ADDENDUM NO. 1
TO
BID PROPOSAL & SPECIFICATIONS
FOR
DOWNTOWN TRUNK SEWER IMPROVEMENTS – PHASE 3
in
ANTIOCH, CALIFORNIA

P.W. 514-S3

ISSUED
SEPTEMBER 15, 2010

CIVIL STANDARD DETAILS - 3

DETAIL 5
NTS

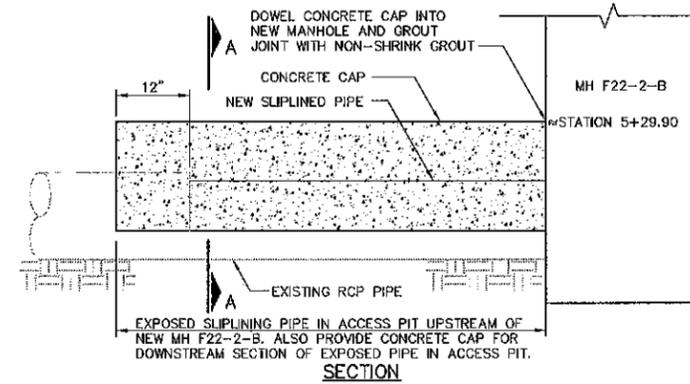
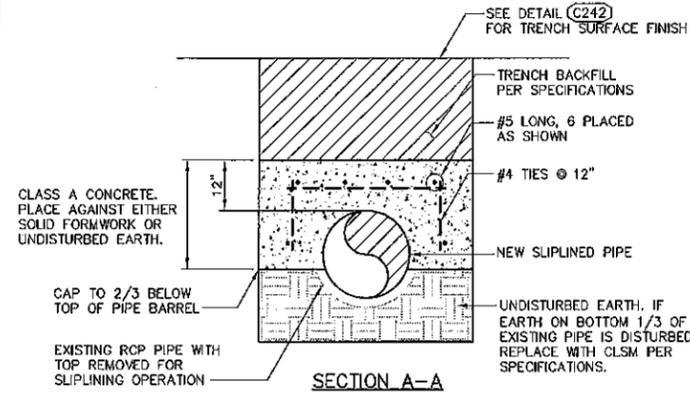
- 1) Replace Drawing GC-3, Sheet 7 of 12 with Revised Drawing GC-3, Sheet 7 of 12 attached.
- 2) Drawing PP-1, Sheet 8 of 12. Add the following call-out to the access pit located at Station 5+29.90:

"Provide concrete cap on portion of new sliplining pipe exposed to the subsurface where the crown was removed from the existing RCP pipe as part of the slipline installation process. See Detail 5/GC-3."

Q: Can the specified pipe (FRP or PVC) be installed as a direct bury non-slipline application at the launch pits?

A: No. See Detail 5 on revised Drawing GC-3, Sheet 7 of 12 attached to this addendum for a guideline of what to do with the section of pipe located in the launch pit.
